LPL-540-1

~~CONFIDENTIAL~~COMMENTS INCLUDED IN NASA LTR SLE-13-63-300REVIEW OF GAEC REPORT NO. LPL-540-19 SEPTEMBER 1963Section

Report: LPL-540-1
Amendment 1
Date: 27 September 1963

FIG. III-9'
NEAR-MOON GEOMETRY

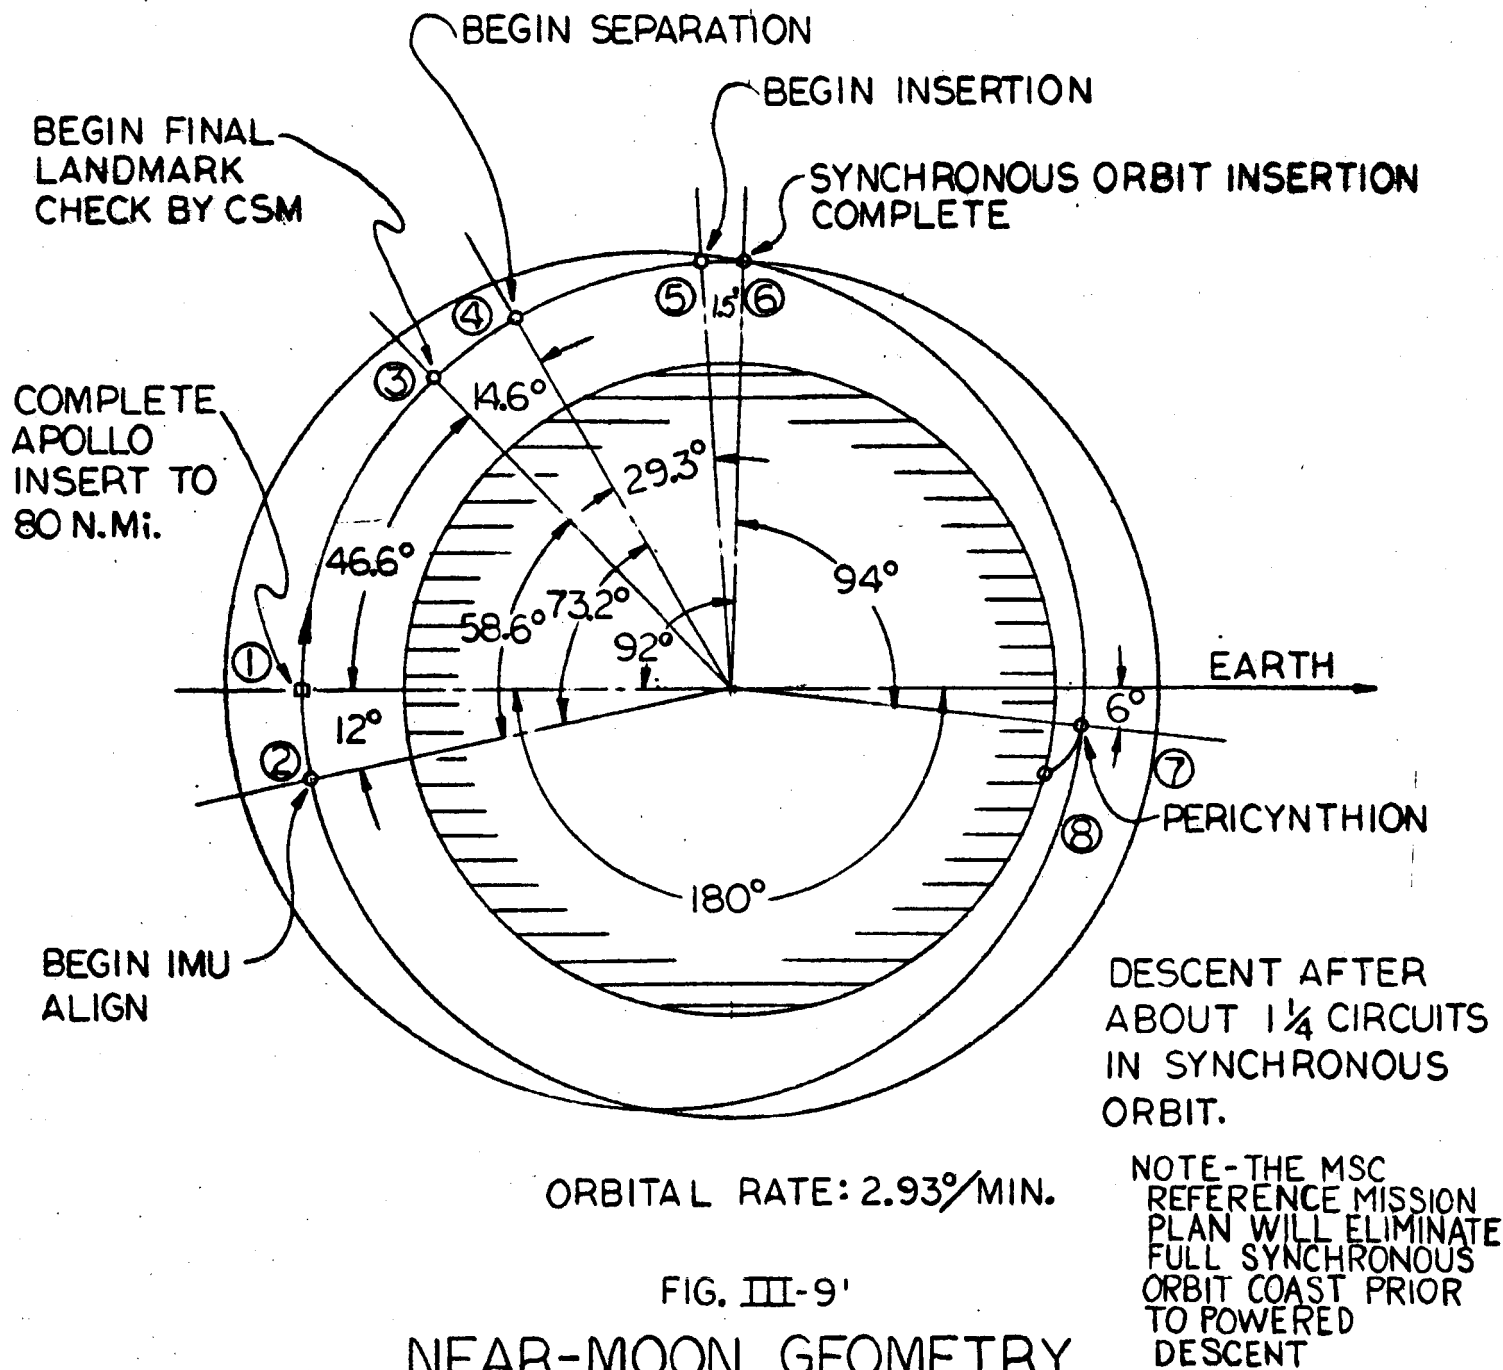
- Figure III-8 - Delete "injection into synchronous orbit 94° from lunar injection point."
- Table III-9 - Change UHF to VHF.
- III K-4 *The LEM does not sight on landmarks because the fixed telescope has only single power optics. The descent transfer orbit ephemeris is to be determined by using the CM radar to track the LEM and/or LEM radar to track the CM. This applies also to Figure III-9, Figure III-10, and Figure III-11.

III K-4 Replace Figure III-9 with Figure III-9' which is enclosed.

(CORRECTION TO MISSION PLAN LPL-540-1)
